Jitter Distributions for 86 & 86A Comments 872, 873, 886 & 793

John Petrilla,
Avago Technologies
January 2010

TP3 Jitter Distributions: Existing Stressed Eye Conditions

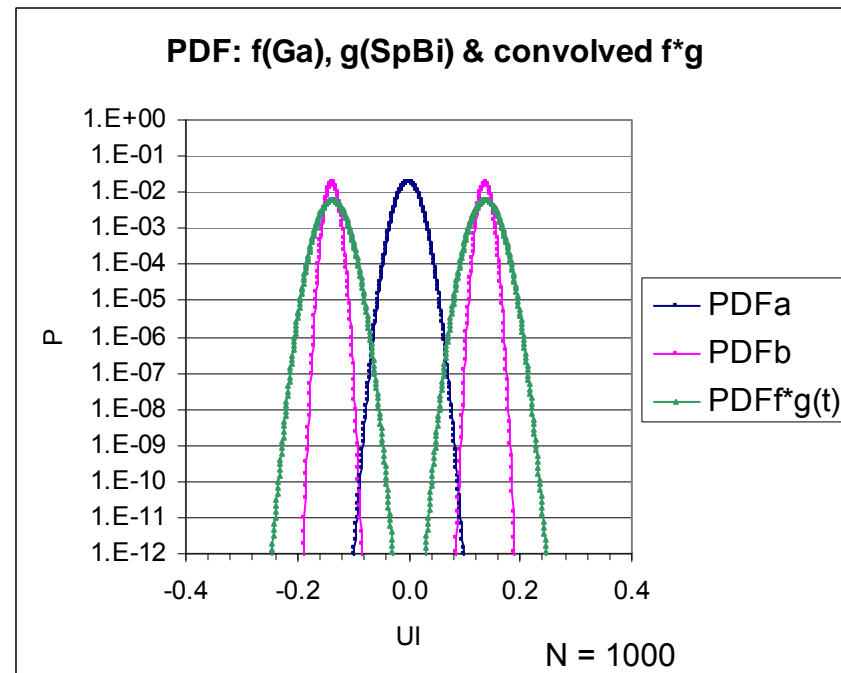
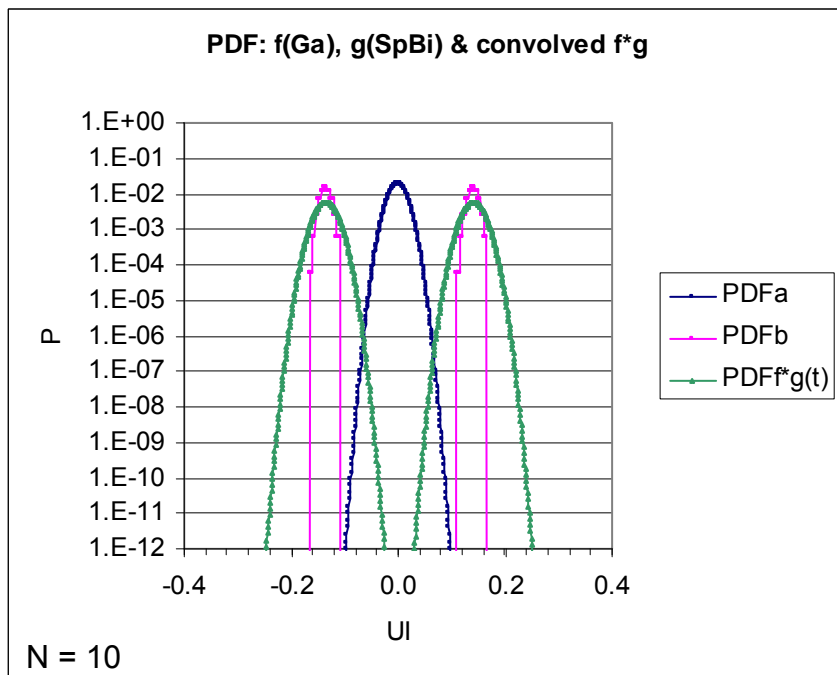
For SR4 and SR10 receivers, receiver tolerance calls for a stressed eye where $J2 = 0.35$ UI and $J9 = 0.47$ UI simultaneously. As can be seen in the above charts, this requirement when modeled using split binominal DDJ and Gaussian RJ appears extreme and may actually be very difficult to generate.

Proposal: In Table 86-8, change the value of J2 from 0.35 to 0.3.

TP3 Jitter Distribution: Proposed Stressed Eye Conditions

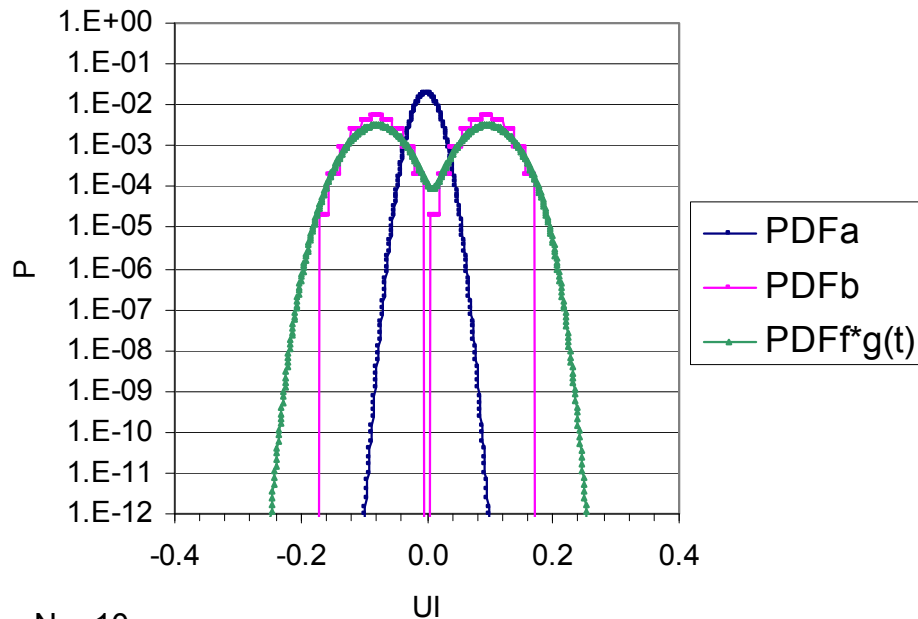
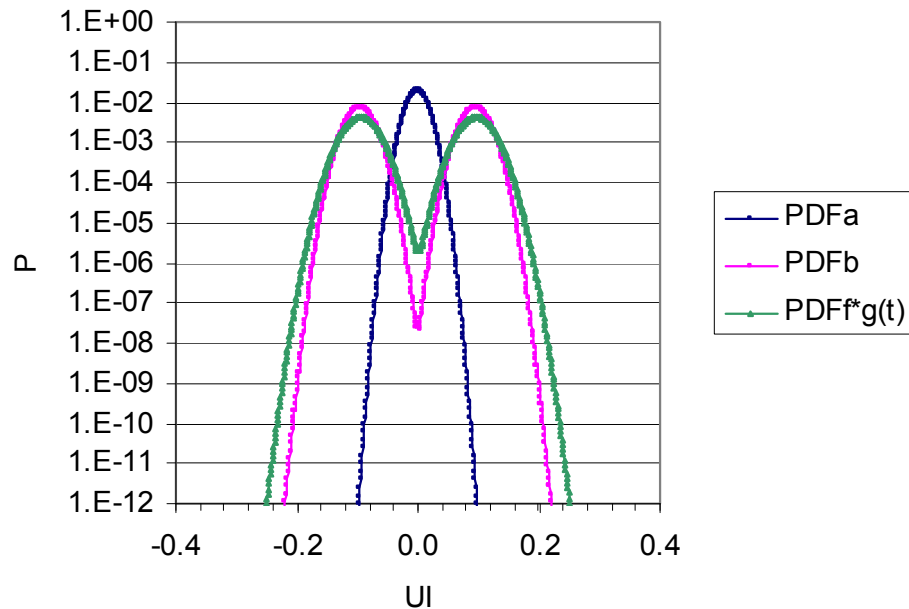
In the above charts, J2 was reduced to 0.30 UI from 0.35 UI. The resulting distribution appears less extreme and more likely to occur in practice.

TP3 Jitter Distributions: Split Binominal & dual-Dirac

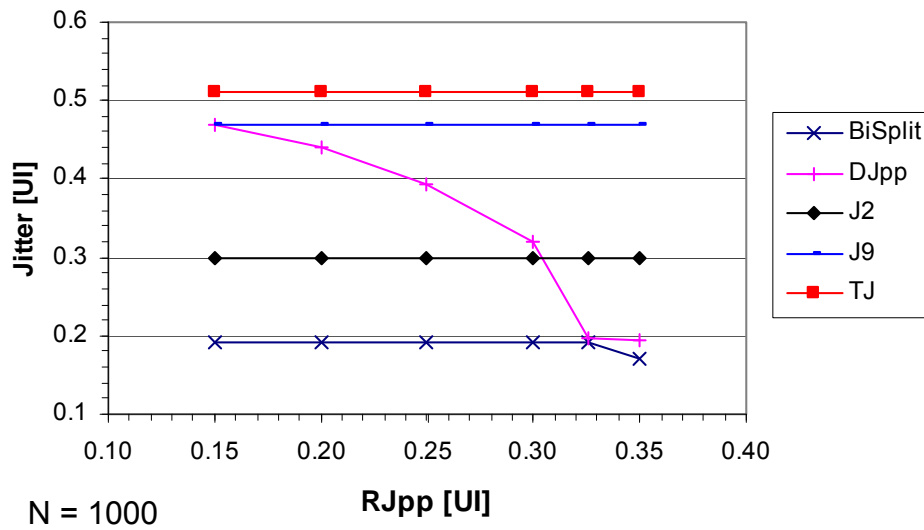
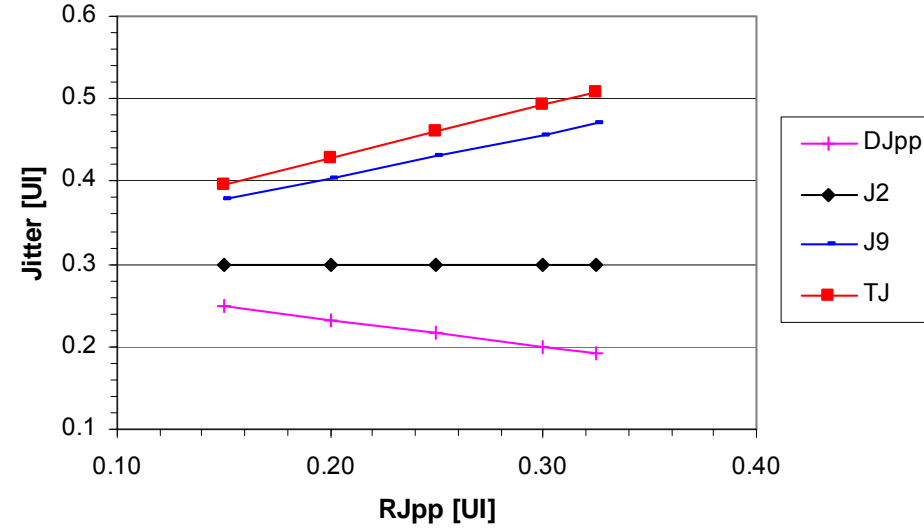
• The above charts show tradeoffs at TP3 between RJ and the other jitter metrics for a split binominal and dual-Dirac probability distribution functions. While a dual-Dirac, Gaussian combination can only satisfy a particular J2, J9 combination, e.g. $J2 = 0.30$ UI and $J9 = 0.47$ UI, for a single RJ, dDJ combination, a split binominal, Gaussian combination can do so over a range of RJ and DDJ.

• It should be noted that these are only two idealized distributions of a great many possible distributions. It seems reasonable to expect that the dual-Dirac distribution represents one extreme. A split binominal distribution may be useful where DDJ distributions are bimodal.

• The proposed split between J2 and J9 appears reasonable in that it can be described by two relatively different jitter distributions and the split binominal distribution used to describe DDJ does not appear extreme.

TP4 Jitter Distribution Analysis

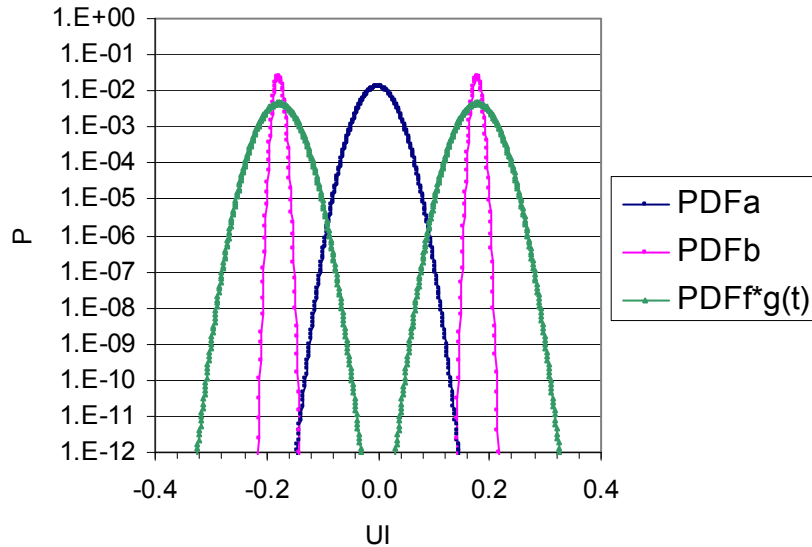
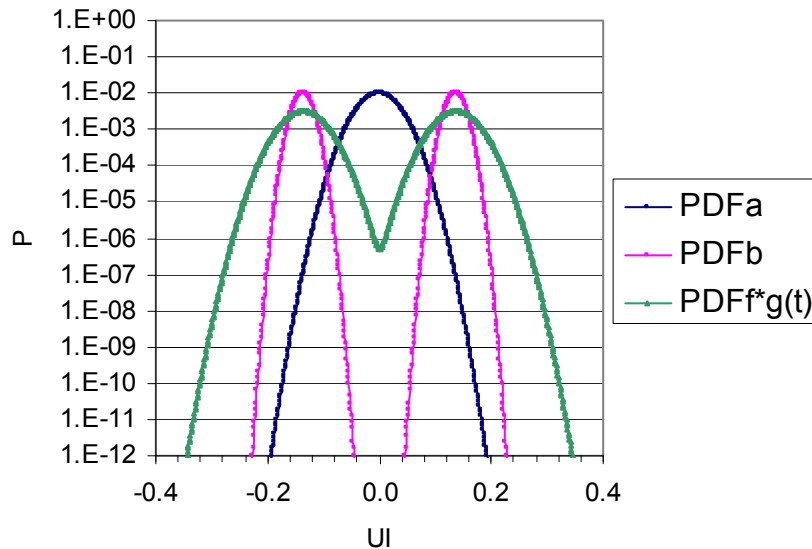
- For SR4 and SR10 receivers at TP4 the existing values for J2 (0.46 UI) and J9 (0.62 UI) are aligned with a TJ of 0.66 UI instead of the current 0.7 UI target.
- As can be seen in the upper chart, a distribution yielding J2 = 0.46 UI and J9 = 0.62 UI when modeled using split binominal DDJ and Gaussian RJ appears extreme and unlikely to occur in practice.
- The lower chart using the proposed values for J2 and J9 from comment 886 is less extreme and should more closely represent worst case distributions found in practice.

Proposal: In Tables 86A-3 and 86A-4 change J2 from 0.46 to 0.42 and J9 from 0.62 to 0.65.

TP4 Jitter Distribution Analysis

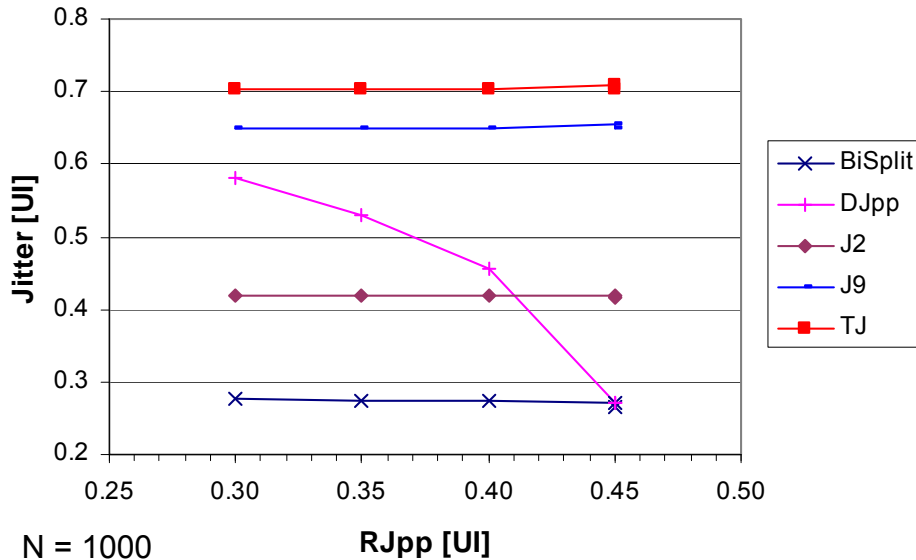
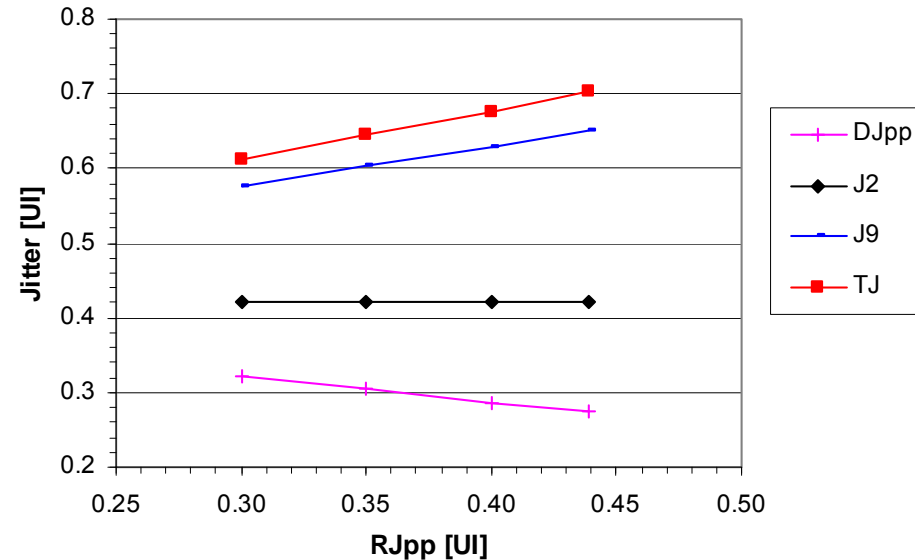
- The above charts show tradeoffs at TP4 between RJ and the other jitter metrics for a split binominal and dual-Dirac probability distribution functions.
- The proposed split between J2 and J9 appears reasonable in that it can be described by two relatively different jitter distributions and the split binominal distribution used to describe DDJ does not appear too extreme.

Center Region Masks & 5E-5 Contour

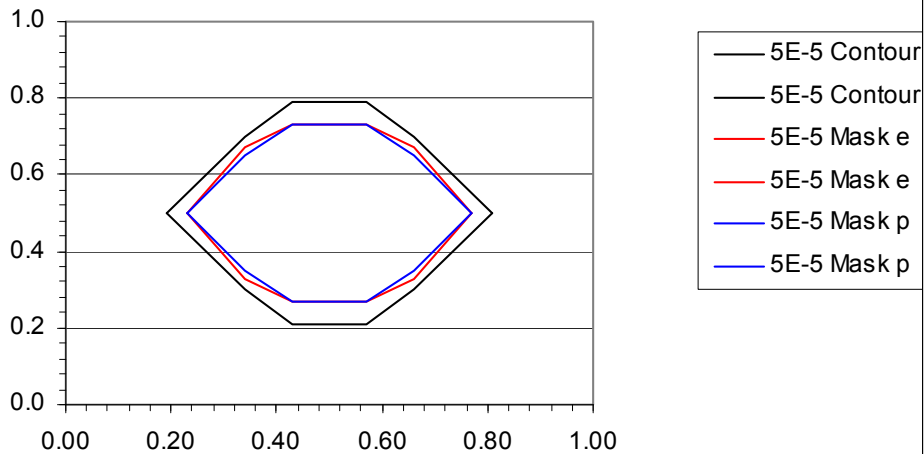
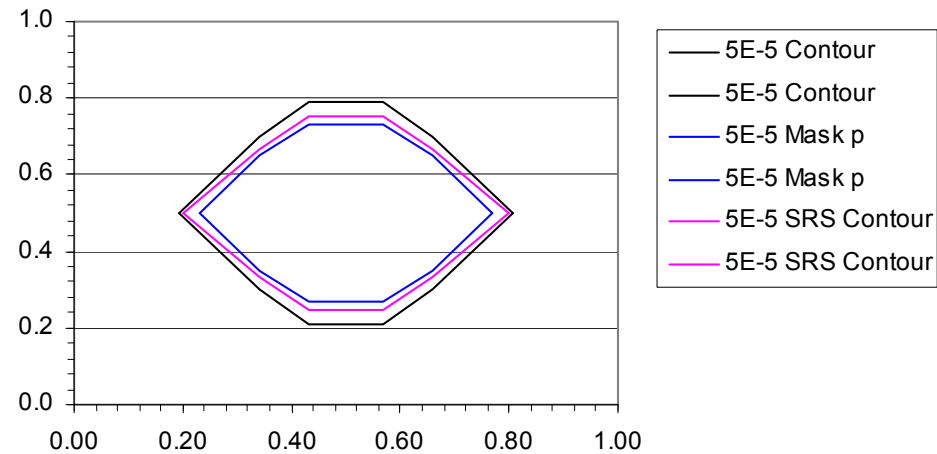
Comment 872: In Table 86-6, the existing Y2 coordinate yields a mask that is not well matched with currently expected worst case Tx output contours.

The chart on the left shows the proposed (p) Tx Mask compared with the existing (e) mask and expected 5E-5 BER contour for the baseline worst case Tx. It may be apparent that the shoulder at the X2, Y2 coordinate presents a point more stressful than the rest of the mask. Since the TDP spec is defined to limit jitter at TP2, it is appropriate for the Tx eye mask to be inside the expected worst case 5E-5 BER contour; the eye mask is to control aberrant signal characteristics such as overshoot and ringing and not add additional burden.

The chart on the right compares the proposed (p) Tx Mask with the same 5E-5 BER contour and with the expected 5E-5 contour from the stressed eye. Here the alignment, while not perfect, appears reasonable.

Proposal: In Table 86-6 change the Y2 coordinate from 0.33 to 0.35 (0.36 would be a better choice by further reducing the shoulder at X2, Y2).

TP1 Jitter Distribution Analysis

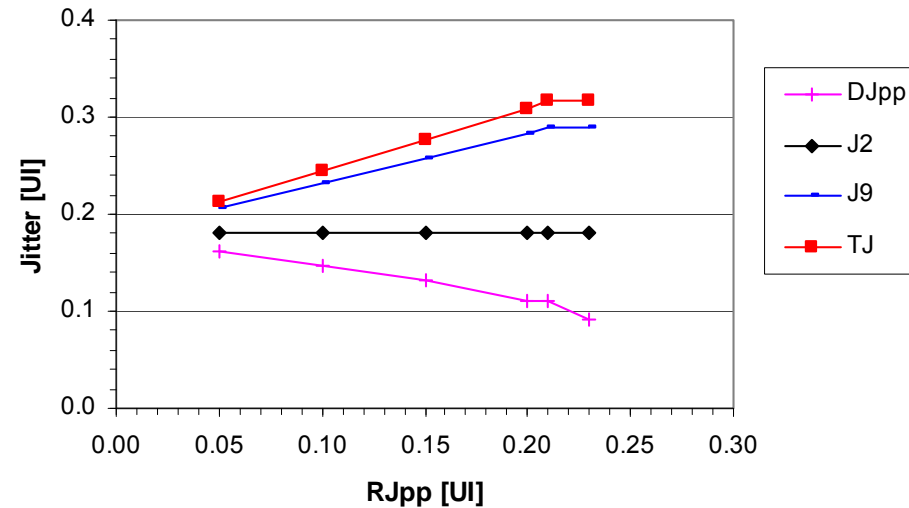
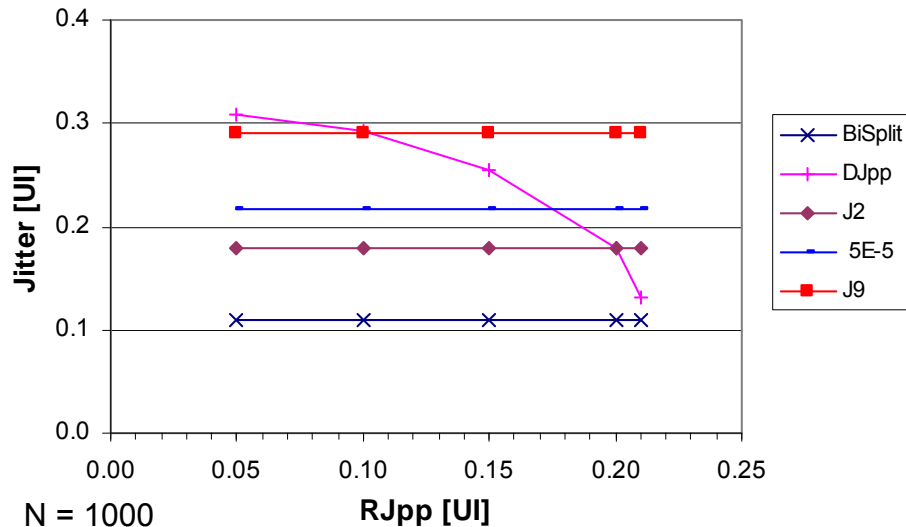
- The above charts show tradeoffs at TP1 between RJ and the other jitter metrics for a split binominal and dual-Dirac probability distribution functions.
- The proposed split between J2 and J9 appears reasonable in that it can be described by two relatively different jitter distributions and the split binominal distribution used to describe DDJ does not appear too extreme.

TP1 Jitter Distribution Analysis

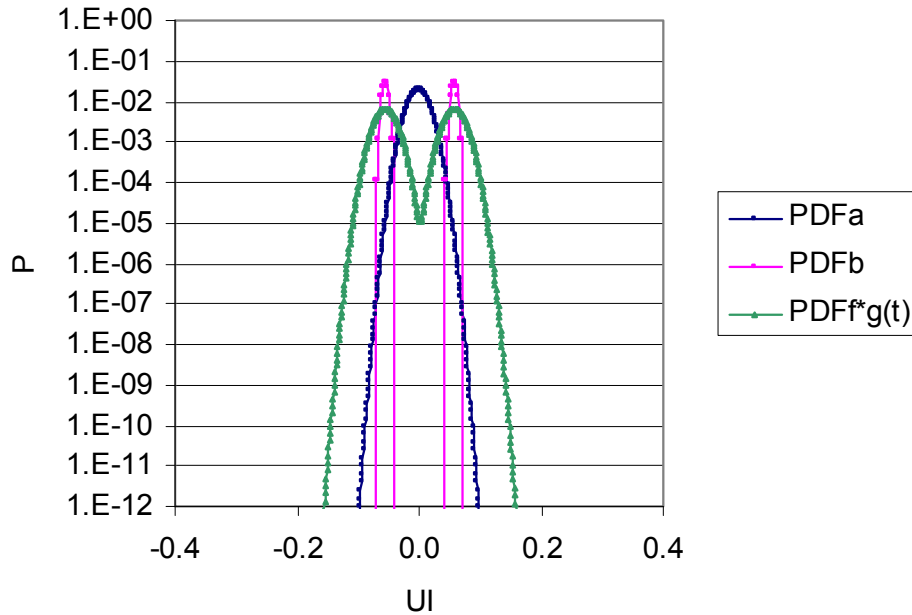
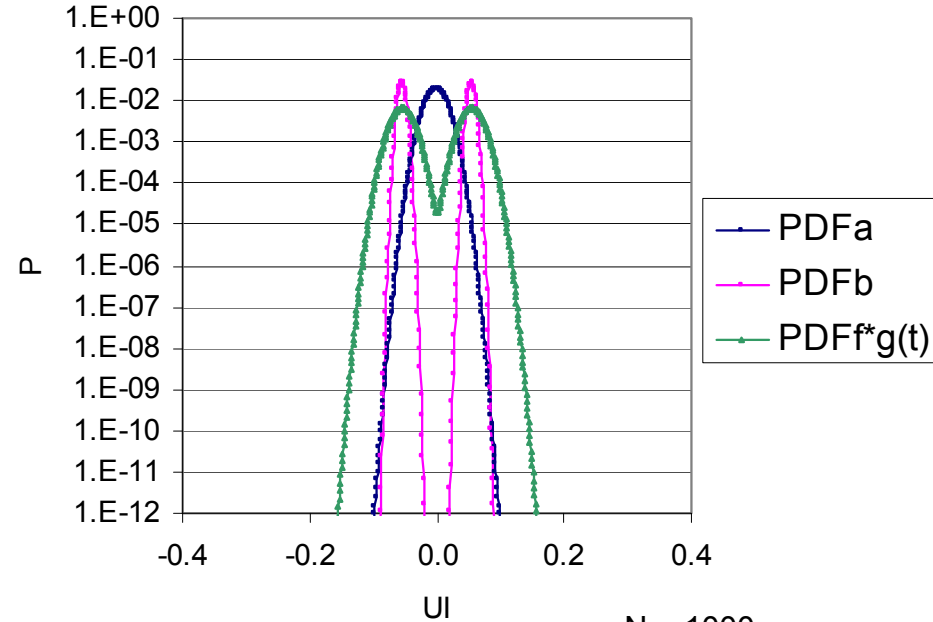
The above charts represent an increase in TP1 J9 from 0.26 UI to 0.29 UI. The bimodal distribution may be associated with either significant under-emphasis or significant over-emphasis.

•A change in TP1 J9 from 0.26 UI to 0.29 UI can be supported without a change in clause 86 optical requirements. The change in TP1 J2 is not required for SR devices and presents an unneeded burden on the host at TP1. Since LR4 only request 0.03UI relief from XLPPI which is provided by the proposed change in TP4 J9, keeping TP1 J2 at 0.18 UI is recommended.
